# SERVICE BULLETIN

BULLETIN NUMBER: 175

MODEL: Diesel Generators WMD, BCD, BTD up to 12.5 KW and BTDA up to 12.5 KW

SUBJECT: Fuel Solenoid #023041 Circuit Improvement

Illustration of Circuit Breaker and Red Wire Lead  
Between the  
Preheat Solenoid and Fuel Solenoid

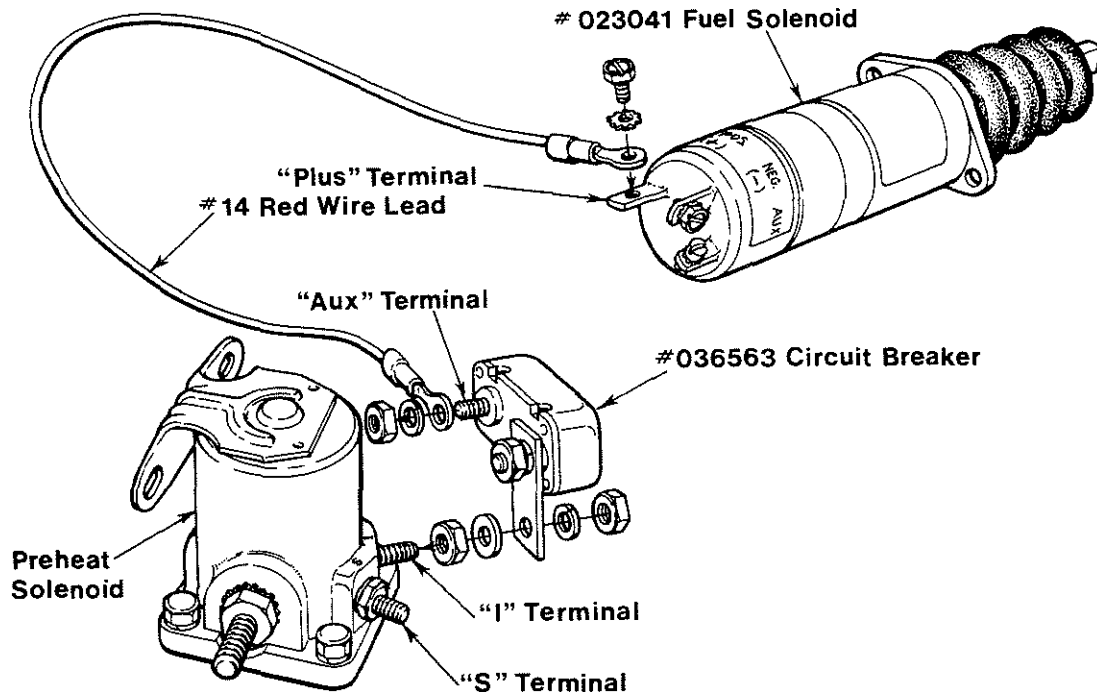
In an effort to prevent fuel solenoid failures that are the result of a voltage loss/reduction in the fuel solenoid circuit during "preheat" and "start," this circuit is now energized using battery voltage available at the "I" terminal on the preheat solenoid when this solenoid is energized during "preheat."

Early model WMD, BCD, BTD and BTDA units up to 12.5 KW can incorporate this circuit by installing circuit breaker assembly #036563 to the vacant "I" terminal of the unit's preheat solenoid and running a #14 red wire from the "aux" terminal of the circuit breaker assembly over to and connecting with the leads presently attached to the "plus" terminal of the fuel solenoid #023041. Ensure this wire is secured and protected against chafing and engine hot areas it passes near.

NOTE: The "I" terminal 10 - 32 threads, circuit breaker connection #10 terminal end for #14 wire, fuel solenoid (plus) terminal #8 terminal end for #14 wire, and #14 wire - length as required.

# WIRING DIAGRAM

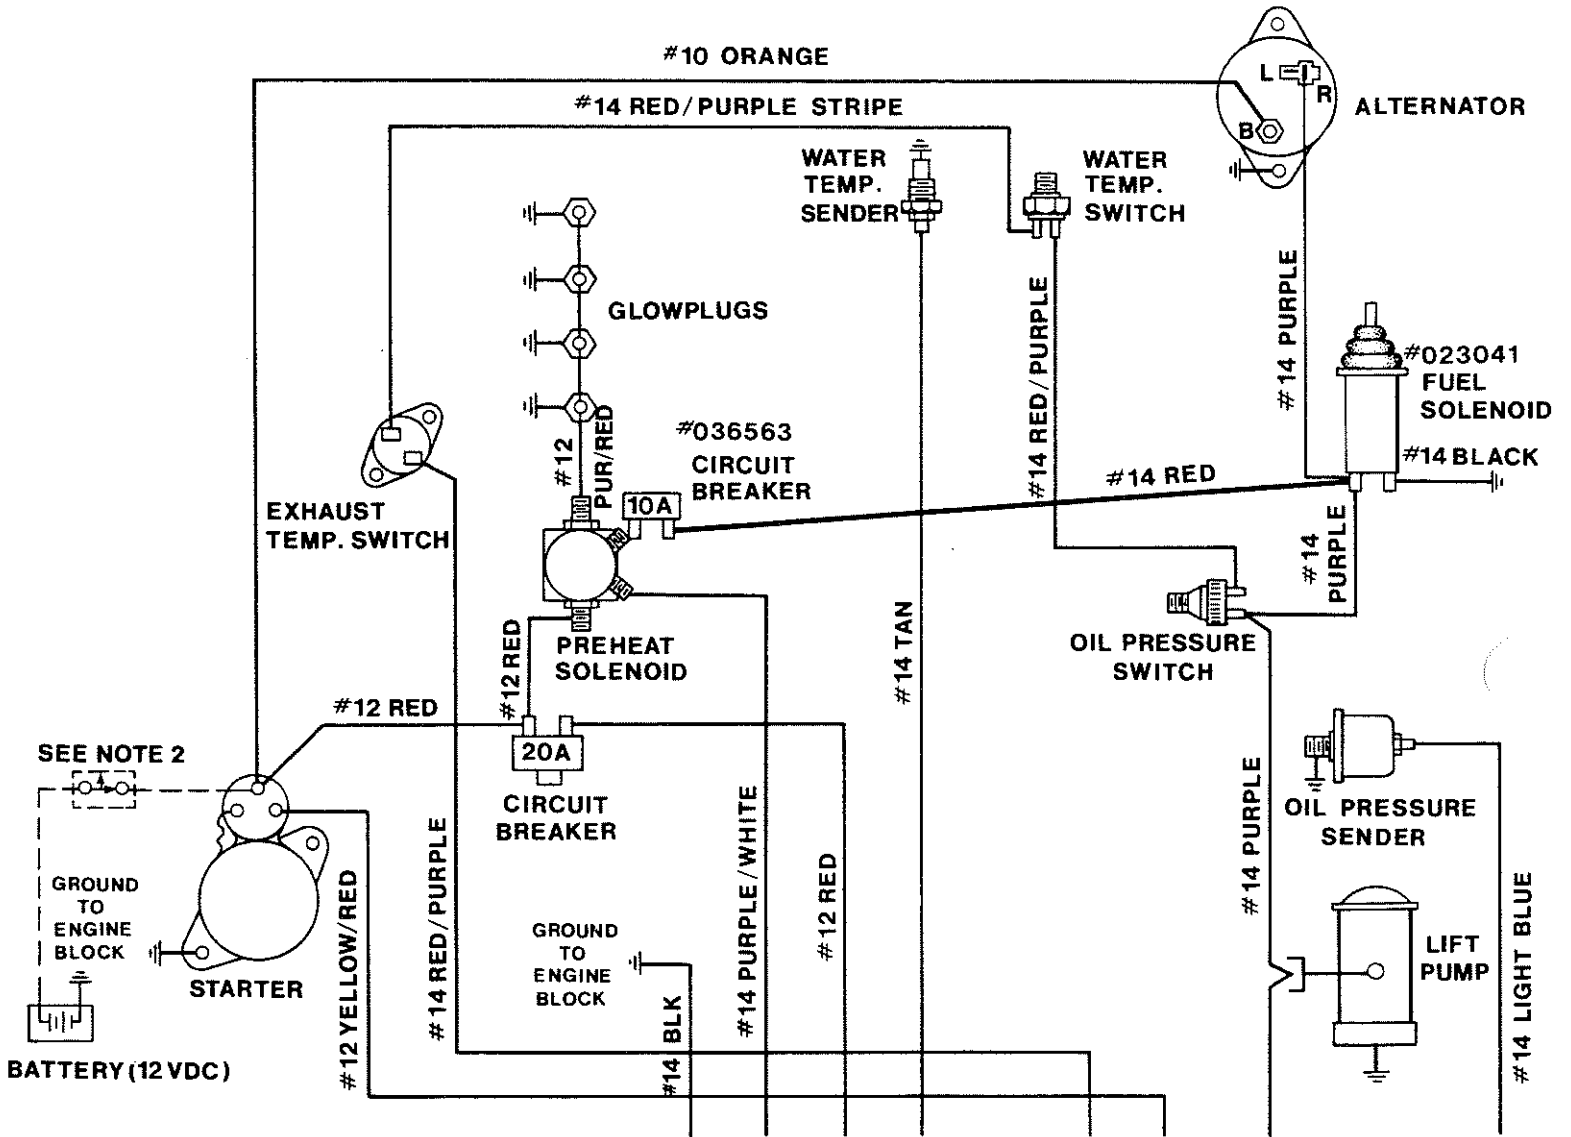
The wiring diagram, on the reverse of this page shows this circuitry being installed on earlier model diesel generators as listed above.
